Nuclear Safety

Advisory Letter

Subject: Barton Model 763, 763A and 764 Transmitters With Defective External Lead Wire Connectors	Number: NSAL-06-13
Basic Components: Barton Model 763 and 763A Gauge Pressure Transmitters and Model 764 Differential Pressure Transmitters	Date: 10/24/2006
Affected Plants: All plants using Barton Model 763, 763A or 764 transmitters	
Substantial Safety Hazard or Failure to Comply Pursuant to 10 CFR 21.21(a)	Yes <input type="checkbox"/> No <input type="checkbox"/>
Transfer of Information Pursuant to 10 CFR 21.21(b)	Yes <input type="checkbox"/>
Advisory Information Pursuant to 10 CFR 21.21(d)(2)	Yes <input checked="" type="checkbox"/>
References: See page 10

Figure 1: Connector Assemblies That Do and Do Not Need to be Inspected

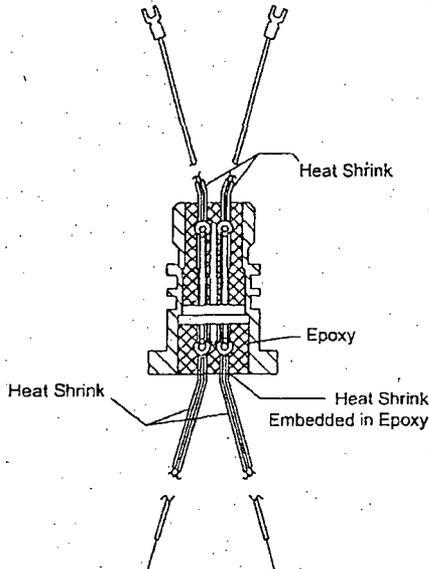
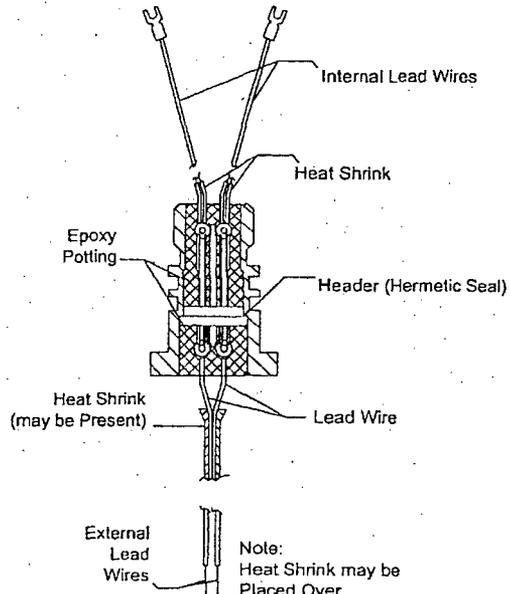
This Configuration should NOT be subjected to the inspection/bend test!

**Connector
(Pre-June 1982)**

Note:
Heat Shrink may be
Placed Over
Individual Leads

**Connector
(Post-May 1982)**

Connector assemblies manufactured prior to June of 1982 were assembled with heat shrink on the external lead wires where they are embedded into the epoxy potting. This configuration is the as-tested configuration and is not subject to the concerns of this Advisory. Any connector assembly with heat shrink applied to each wire individually that enters the epoxy potting is not considered defective and need not be replaced. In June of 1982 the heat shrink on each of the two wires was eliminated as a design improvement.

For connector assemblies that are installed on transmitters that could be subjected to a potential harsh environment associated with a LOCA or HELB environment and include installations that do not include environmentally sealed conduit connectors, Westinghouse recommends that customers replace the external lead wire connector assemblies manufactured and supplied after May 1982 and before June 1, 2006 during their next scheduled outage after parts are available. The inspection defined in Reference 1 is not required, since Westinghouse is recommending replacement of all post-May 31, 1982 connector assemblies in these specific installations. Westinghouse also recommends that the licensee evaluates the potential impact on the safety-related functions provided by Westinghouse qualified Barton Model 763, 763A and 764 transmitters.

PRIME recommends that all connectors in transmitters manufactured after May of 1982 be inspected for exposure of the external lead-wire conductors at the surface of the connector. This inspection will necessitate that the connector be unscrewed from the transmitter following the instructions in the Installation and Operation Manual using a special connector removal/installation tool (PRIME P/N 0764-1174B). The external lead wires should be flexed during this inspection to assure that the insulated portions of the wires are securely embedded into the epoxy. The external wires can be flexed 90° such that the insulated portion of the wires touches the flange of the connector assembly. The area of the insulated wire penetration into the epoxy potting should be visually inspected for any evidence of the wire conductors while the wires are flexed. The 90° flex test should be repeated by flexing the external lead wires in the opposite direction. Any connector where the conductors of either wire are observable should be considered defective and replaced.
